Prairie Island Nuclear Generating Plant, Units 1 and 2  
Dockets 50-282 and 50-306  
Renewed License Nos. DPR-42 and DPR-60

License Amendment Request for Spent Fuel Pool Criticality Changes

## **ENCLOSURE 1**

### **Evaluation of the Proposed Change**

Figure 3.7.17-1  
Spent Fuel Pool Unrestricted Region Burnup and Decay Time Requirements

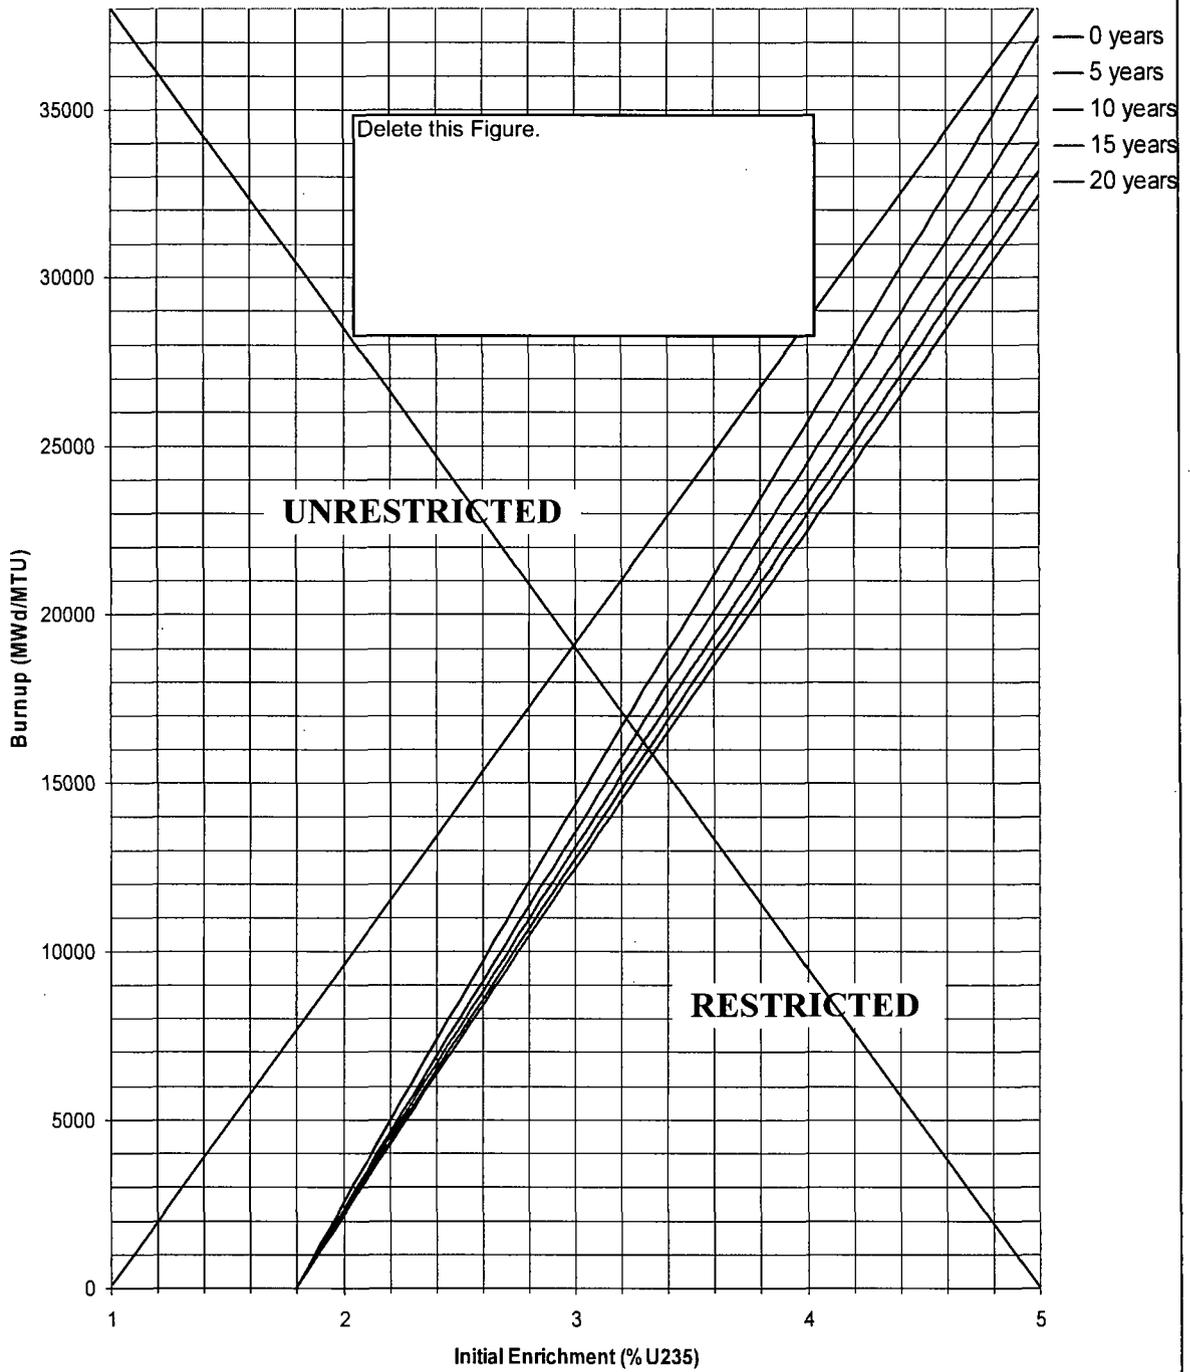
The proposed change will replace all previous loading restrictions in TS 3.7.17 and 4.3.1.1 with new loading restrictions. Specific to TS 3.7.17, the proposed change will remove TS Figure 3.7.17-1 and refer to TS 4.3.1.1 for all SFP loading restrictions; thereby eliminating the concept of "restricted" and "unrestricted" loading in the SFP.

The proposed revision to TS 3.7.17 eliminates Figure 3.7.17-1 and the related terms of "restricted" and "unrestricted". In effect, the new loading restrictions have made this concept of "unrestricted" storage obsolete because there are no "unrestricted" fuel categories in the proposed TS. Even a fuel assembly that meets the high-burnup Category 6 must meet other restrictions. For example, it must be placed in a qualified array and meet the prescribed interface requirements. Therefore, the concept of "restricted / unrestricted" storage is eliminated and replaced with a complete set of new loading restrictions embodied entirely in TS 4.3.1.1.

- d. A nominal 9.5 inch center to center distance between fuel assemblies placed in the fuel storage racks;
- e. New or spent fuel assemblies with a combination of discharge burnup, initial enrichment and decay time in the "unrestricted range" of Figure 3.7.17-1 may be allowed unrestricted storage in the fuel storage racks; and

- f. New or spent fuel assemblies with a combination of discharge burnup, initial enrichment and decay time in the "restricted range" of Figure 3.7.17-1 will be stored in compliance with Figures 4.3.1-1 through 4.3.1-4.

Figure 4.3.1-1  
 Spent Fuel Pool Burned/Fresh Checkerboard Cell Layout

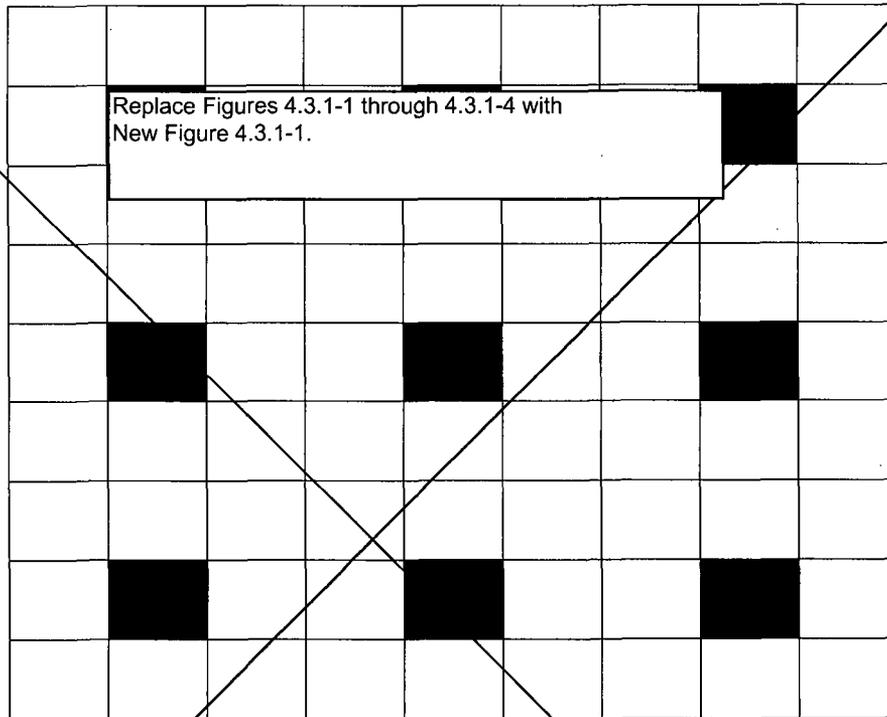
The proposed change will modify sub-item (e) to apply the new loading requirements of TS Figure 4.3.1-1 and expand the scope to include fuel inserts and hardware. Sub-item (f) is eliminated entirely. Accordingly, the proposed change will replace current loading restrictions in TS Figures 4.3.1-1 through 4.3.1-

4 with new loading restrictions embodied by TS Tables 4.3.1-1 through 4.3.1-3 and TS Figure 4.3.1-1.

The proposed Figure 4.3.1-1 makes provisions for spent fuel pool contents that were not previously included in the TS. These contents include consolidated rod storage canisters, failed fuel baskets, and fuel assembly inserts.

- Figure 4.3.1-1 provides the Spent Fuel Pool Loading Restrictions. Once the fuel assemblies are categorized per the Tables in TS 4.3.1, this figure describes the loading configurations (described as “arrays”) that ensure subcriticality criteria are satisfied. These proposed loading restrictions address new entities that had not been previously subject to TS: (1) consolidated rod storage canisters (CRSCs) and associated non-fissile hardware, (2) fuel rod storage canisters (FRSCs), (3) failed fuel pin baskets (FFPBs), and (4) fuel assembly inserts. In addition, one array (Array G) takes credit for the insertion of a Rod Cluster Control Assembly (RCCA) in a spent fuel assembly, whereas RCCAs had not been previously credited. This figure is an output of the SFCA.

- A. Any array of storage cells containing fuel shall comply with the storage patterns in Figure 4.3.1-1 and the requirements of Tables 4.3.1-1, 4.3.1-2, and 4.3.1-3 as applicable. The category number of fuel assemblies selected for a 2x2 or 3x3 array (category determined using Table 4.3.1-2 or 4.3.1-3) shall be equal to or greater than the category number shown in the respective figure.
- B. Any storage array location designated for a fuel assembly may be replaced with a failed fuel basket (fuel rod storage canister or failed fuel pin basket), incore detectors, or other non-fissile hardware.
- C. Fuel assembly inserts designed for use in the reactor core may be inserted in a stored assembly (in the Spent Fuel Pool) without affecting the fuel category.

1. In all arrays, an assembly of higher Fuel Category number can replace an assembly designated with a lower Fuel Category number.
2. Category 1 is fuel up to 5.0 weight percent U-235 enrichment and does not credit burnup.
3. Fuel Categories 2 through 6 are determined from Tables 4.3.1-2 or 4.3.1-3.
4. An "R" designates a location that requires insertion of an RCCA in the fuel assembly.
5. An "X" designates a location that requires an empty cell, except that the empty cells in Array F may store assembly structural materials including nozzles, guide tubes, and grids.
6. An empty (water-filled) cell may be substituted for any fuel-containing cell in all storage arrays.
7. Array F shall only interface with Array A, and no other.

Figure 4.3.1-2  
Spent Fuel Pool Checkerboard Interface Requirements

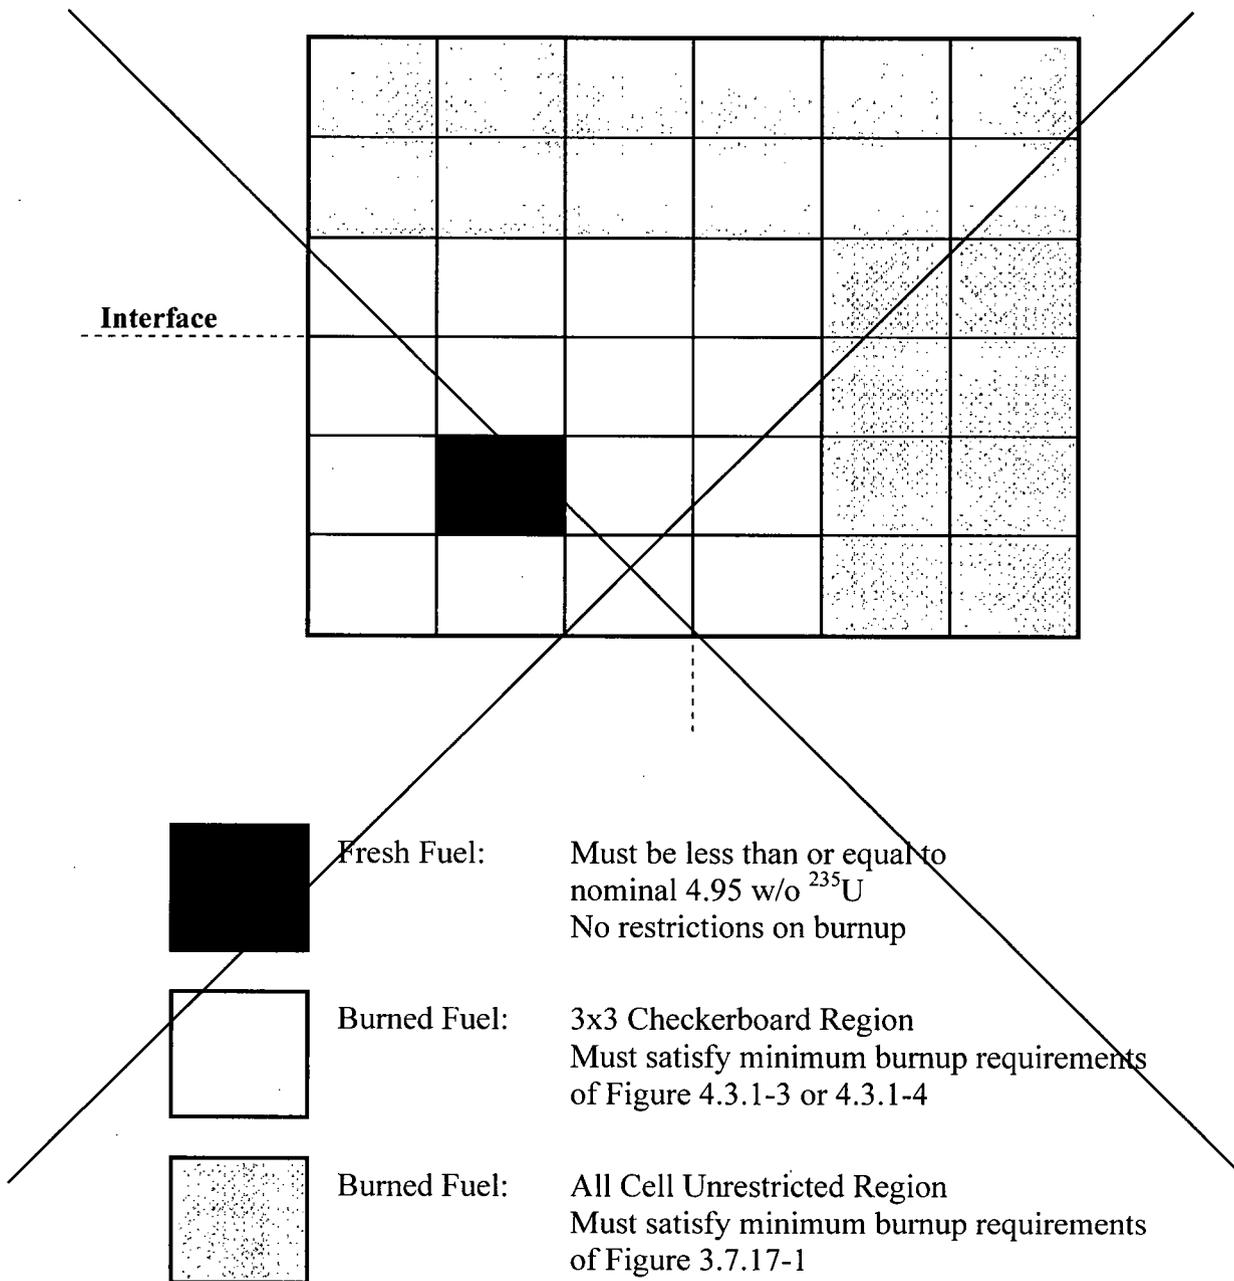
~~b. The interface must be configured such that there is one row carryover of the pattern of burned assemblies from the checkerboard region into the first row of the unrestricted region (Figure 4.3.1-2).~~
